**CERTIFICATE OF APPROPRIATENESS**

**Property:** 1405 Allston St, Lot 10, Block 154, Houston Heights Subdivision. The property includes a historic 2,156 square foot, wood frame single-family residence and a detached carport situated on a 6,600 square foot (50' x 132') interior lot.

**Proposal:** **Alteration:** Siding, windows, addition.

**Recommendation:** Denial of COA and issuance of a COR for proposed work.

**Side Wall Length and Insets (Addition and New Construction)**

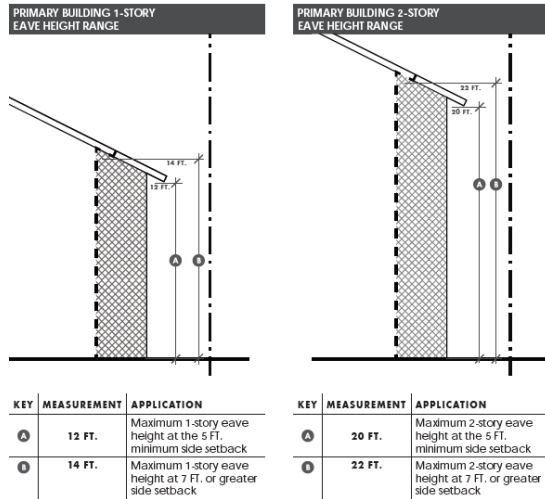
Inset on the south elevation but not on the north one.

Applicant is maintaining three corners as recommended by Heights Design Guidelines and adding a vertical trim board and a roof detail where the original corner was.

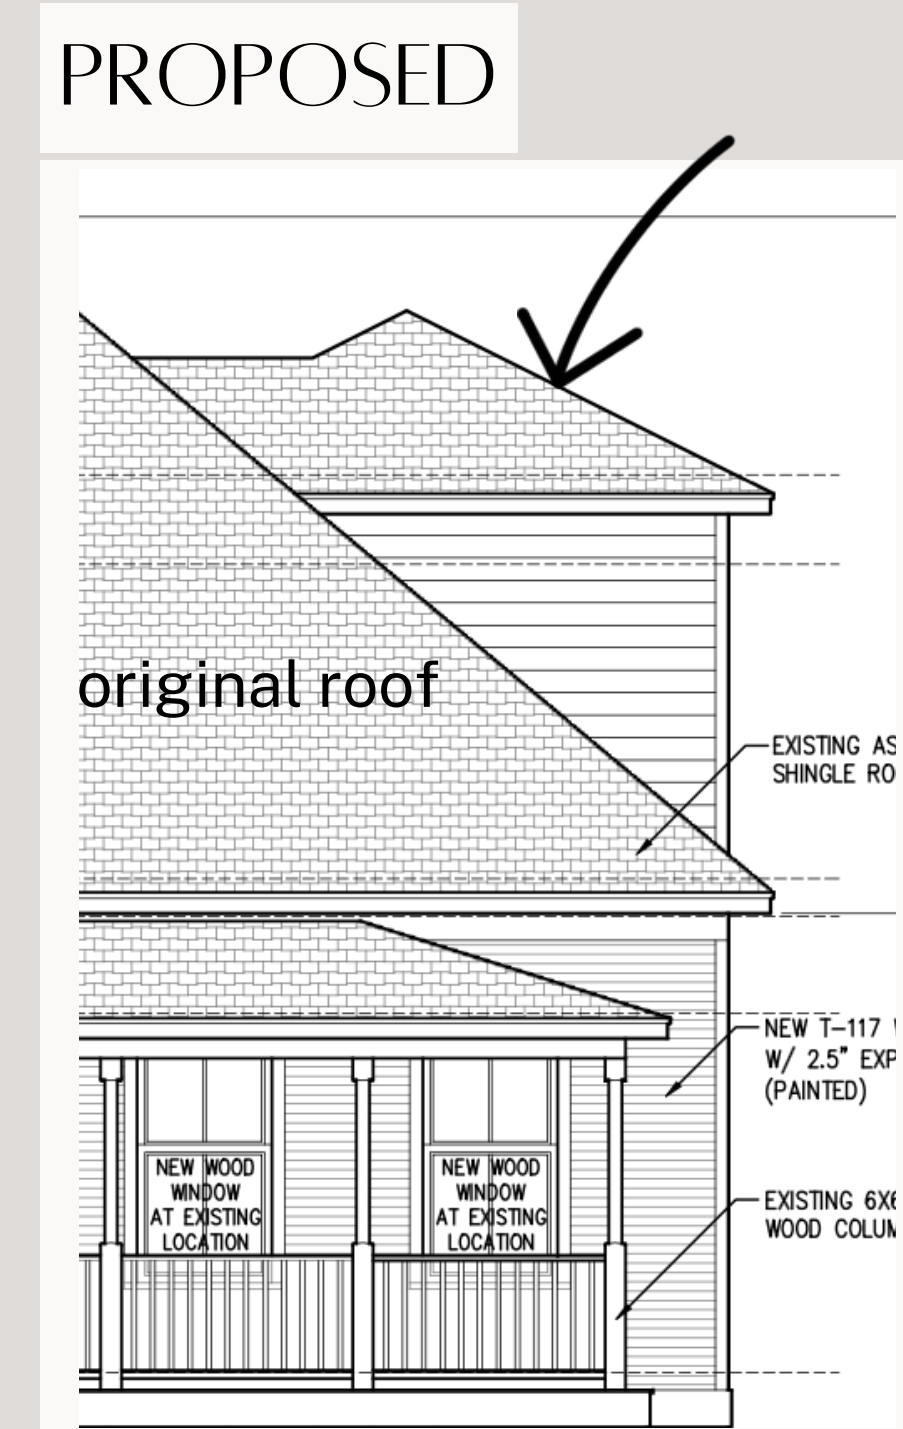
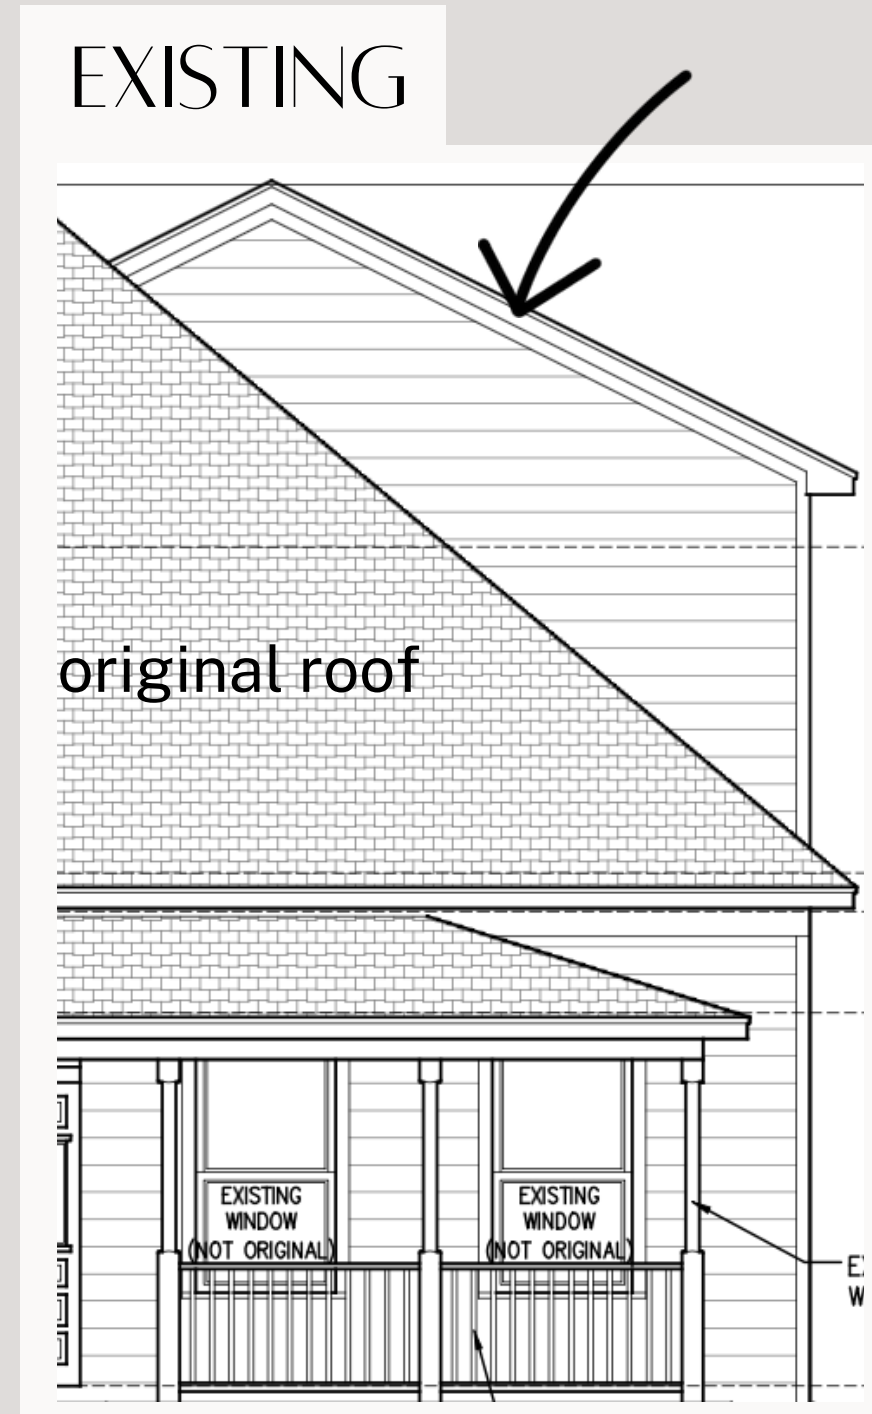
Keep the existing foot print but meet the FAR guidelines by creating attic space where the original attic was once located.

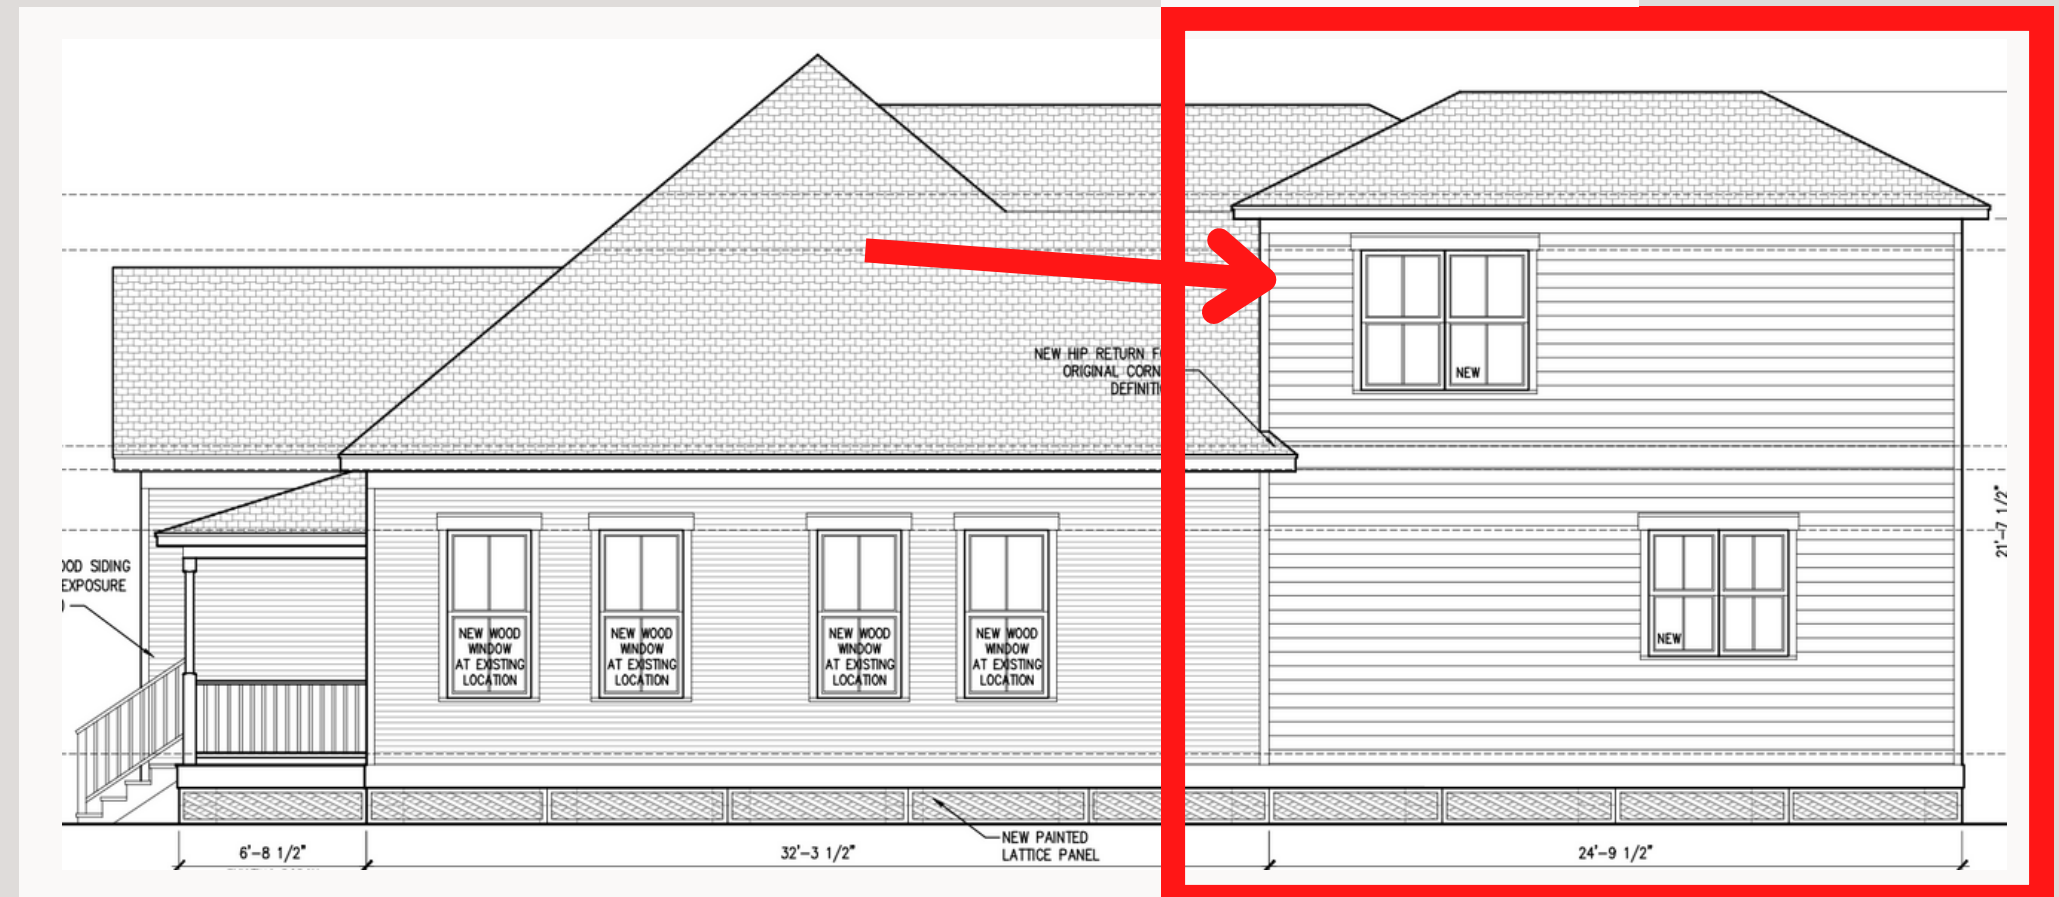
Keep the existing addition's north wall as-is with no 2ft inset, due to the following considerations...

(a trim piece to be added to differentiate the original home from the addition)
